Addendum 128 – UN Regulation No. 129

Revision 3 - Amendment 4

Supplement 5 to the 02 series of amendments – Date of entry into force: 11 January 2020

Uniform provisions concerning the approval of Enhanced Child Restraint Systems used on board of motor vehicles

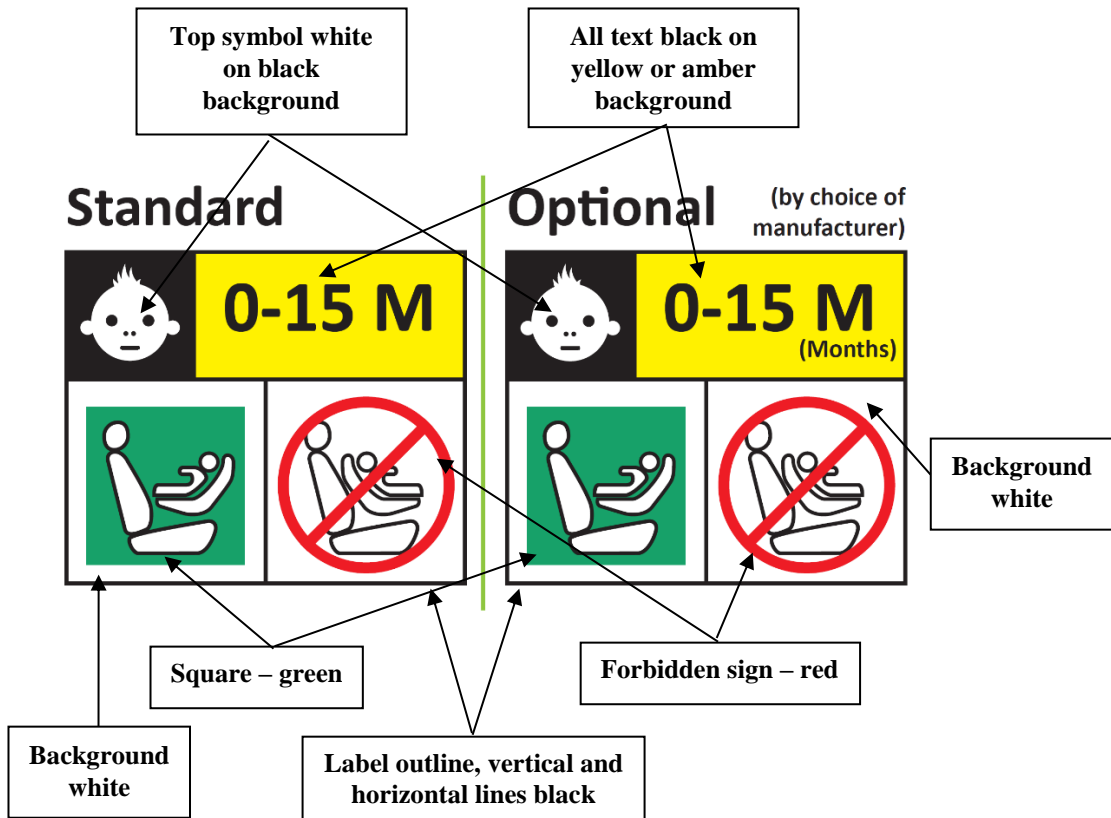
Paragraph 4.5., amend to read:

"4.5. Integral Enhanced Child Restraint Systems that can be used forward and rearward facing, shall have the following label permanently attached on the part hosting the child and visible to the person installing an Enhanced Child Restraint System in the vehicle:

The manufacturer shall be permitted to include the word "months" to explain the symbol "M" in the label. The word "months" should be in a language commonly spoken in the country or countries where the product is sold. More than one language is allowed.

Minimum label size 40 x 40 mm

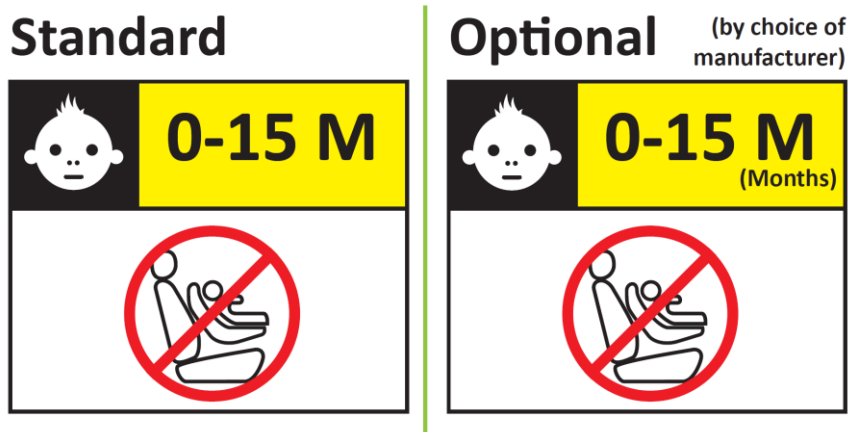
Integral Enhanced Child Restraint Systems that can be used forward facing only shall have the following label permanently attached on the part hosting the child and visible to the person installing an Enhanced Child Restraint System in the vehicle:

The manufacturer shall be permitted to include the word "months" to explain the symbol "M" in the label. The word "months" should be in a language commonly spoken in the country or countries where the product is sold. More than one language is allowed.

Minimum label size 40 x 40 mm

Figure 1
Arrangement for testing a forward-facing device

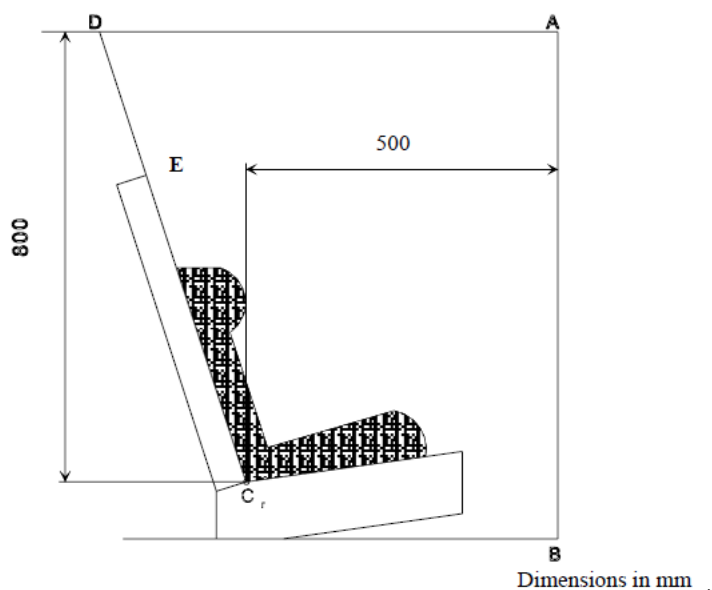
Paragraphs 6.6.4.4.1.1. and 6.6.4.4.1.1.1., amend to read:

"6.6.4.4.1.1. Forward facing Enhanced Child Restraint Systems

Head excursion: No part of the head of the dummy shall pass beyond the planes BA, DA and DE as defined in Figure 1 below. However, the head of the dummy may pass beyond the DE plane, if there is part of the child restraint structure, i.e. head pad or backrest, behind the head of the dummy, at the point the head passes the DE plane.

This shall be judged up to 300 ms or the moment that the dummy has come to a definitive standstill whatever occurs first.

Except for booster seats when testing using Q10 dummy where:

- (a) The value in relation to the DA plane is 840 mm; and
- (b) The value in relation to the BA plane is 550 mm; and
- (c) The rebound phase is not considered for the assessment of the plane DA and DE.

6.6.4.4.1.1.1. Where a test is conducted in accordance with paragraph 6.6.4.1.6.2. or paragraph 6.6.4.1.8.2. above, a tolerance of +10 per cent shall be applicable to the head excursion value distance between Cr point and plane AB.

Arrangements of the approval mark

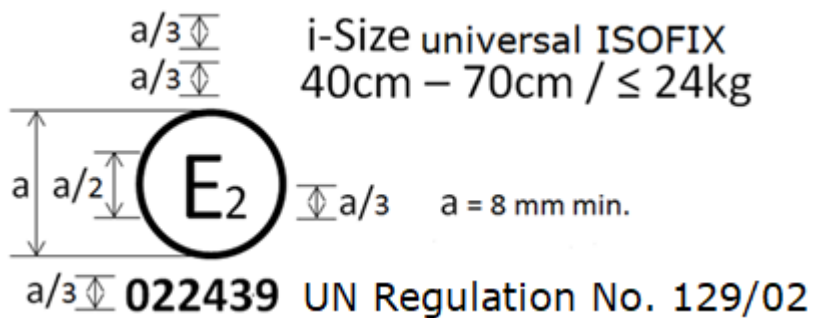
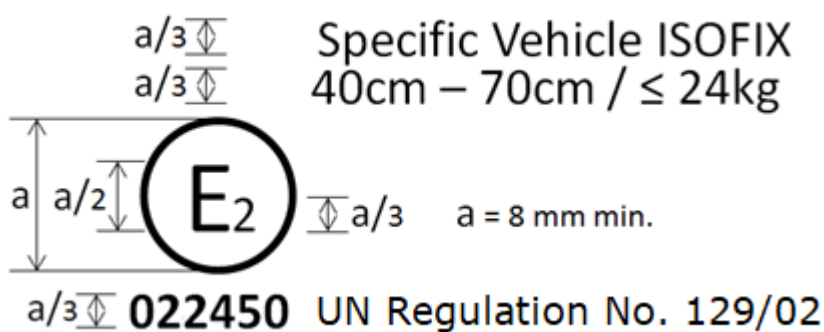
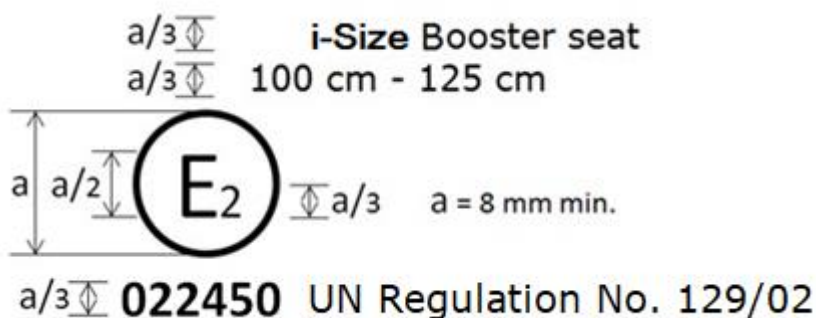
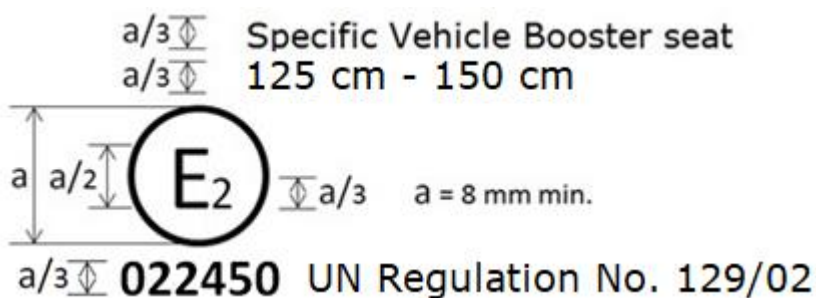
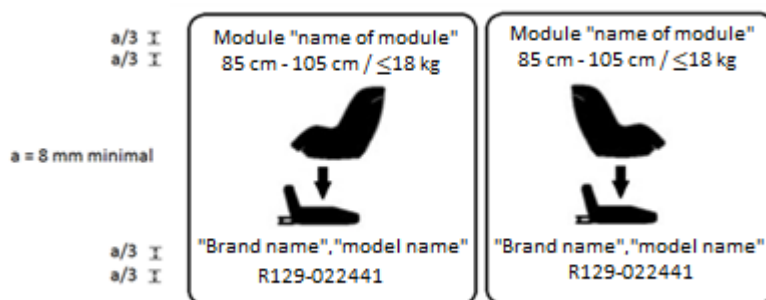
Annex 2., amend to read:

The Enhanced Child Restraint System bearing the above approval mark...125 cm–150 cm size range...

In case of combinations, for example an Enhanced Child Restraint System, that is approved as an i-Size Booster seat from 100 cm – 125 cm and from 125 cm – 150 cm as a Specific Vehicle Booster seat, the approval marked is to be combined as given below.

Combinations can only be made for those allowed by paragraph 3.2.2.

Arrangements of the module mark in combination with an approval mark

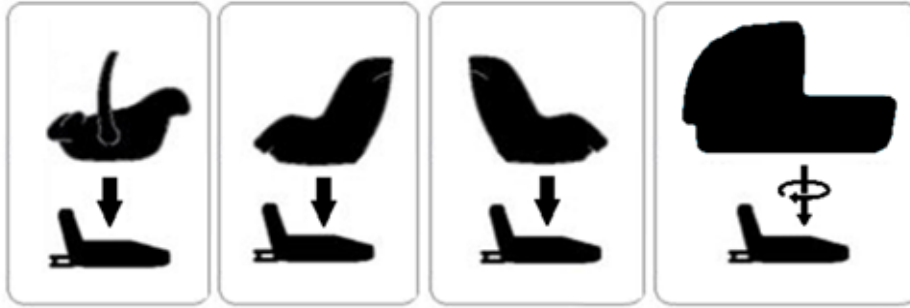
Current examples given to be deleted and replaced by the following:

The Enhanced Child Restraint System module bearing the above module marks is capable of being used in a rearward facing mode with the base "brand name and model name", for the 85 cm–105 cm size range and with a mass limit of 18 kg; approved according to UN Regulation No. 129-02 under the number 022441.

The Enhanced Child Restraint System module bearing the above marks is also capable of being used in a forward facing mode with the base "brand name and model name", for the 85 cm–105 cm size range and with a mass limit of 18 kg; approved according to UN Regulation No. 129-02 under the same number 022441.

The approval number indicates that the approval was granted in accordance with the requirements of the UN Regulation concerning the approval of Enhanced Child Restraint Systems used on-board motor vehicles as amended by the 02 series of amendments.
